To: Honorable Mayor Patrick Collins and Members of the City Council
From: Connor White, Planner II
Subject: UDC-21-00094 / Sweetgrass, 7th Filing / Final Plat
Date: July 7, 2021

STAFF REPORT

FILE: UDC-21-00094: Sweetgrass, 7th Filing Preliminary Plat (Expedited Request)

TEMPORARY ACCESS ROAD

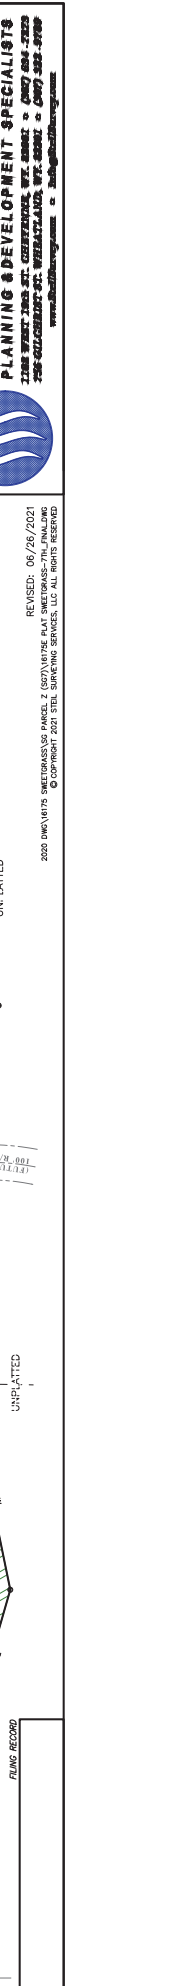
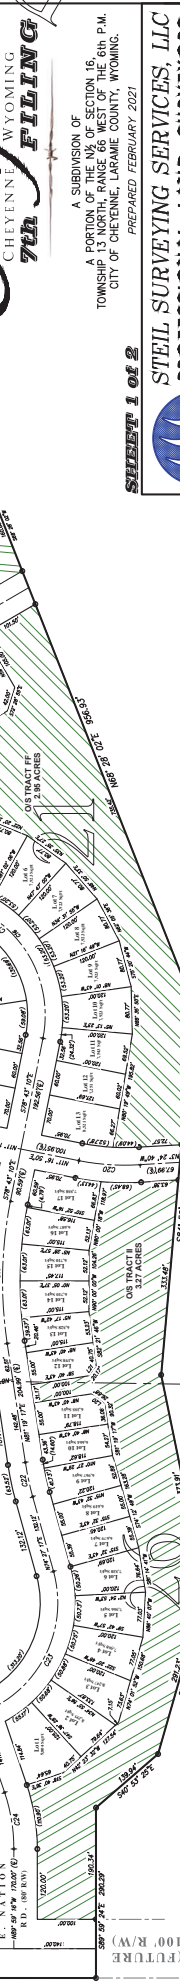
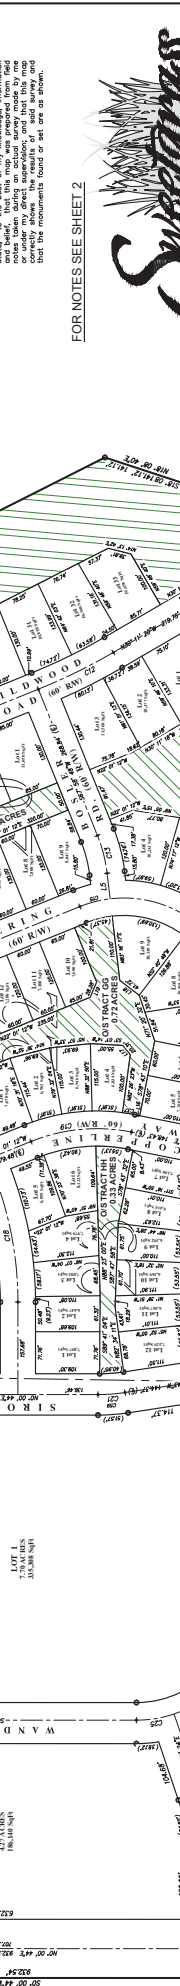
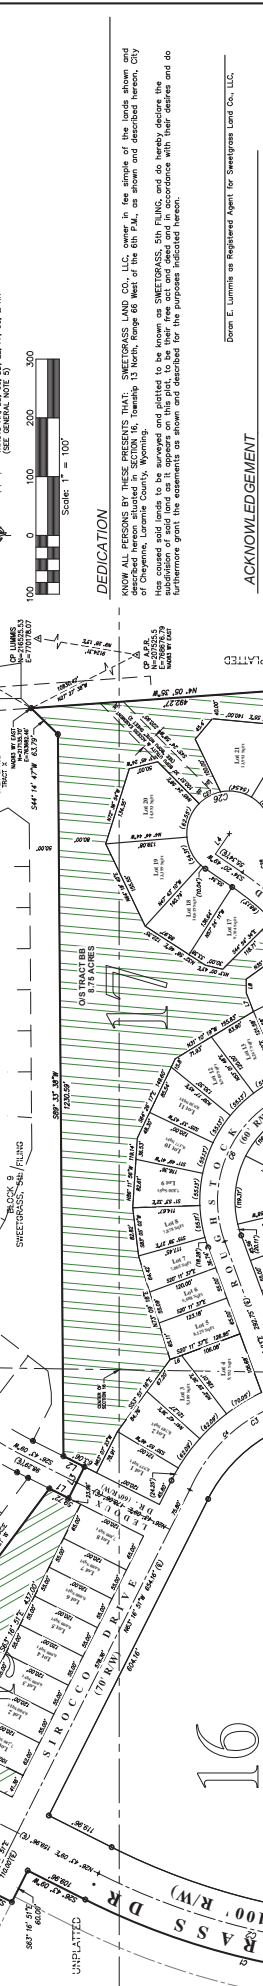
7. Secondary access road for Emergency response must meet IFC Appendix D requirements. An exhibit should be show with the preliminary plat showing the location, grade, and how it meets IFC requirements needs to be provided. (provided)

The Fire Department also asks that the applicant provide a temporary fire access to the west with their future Engineering Plan Review submittal and subdivision construction. The applicant has provided a document showing the proposed secondary access.
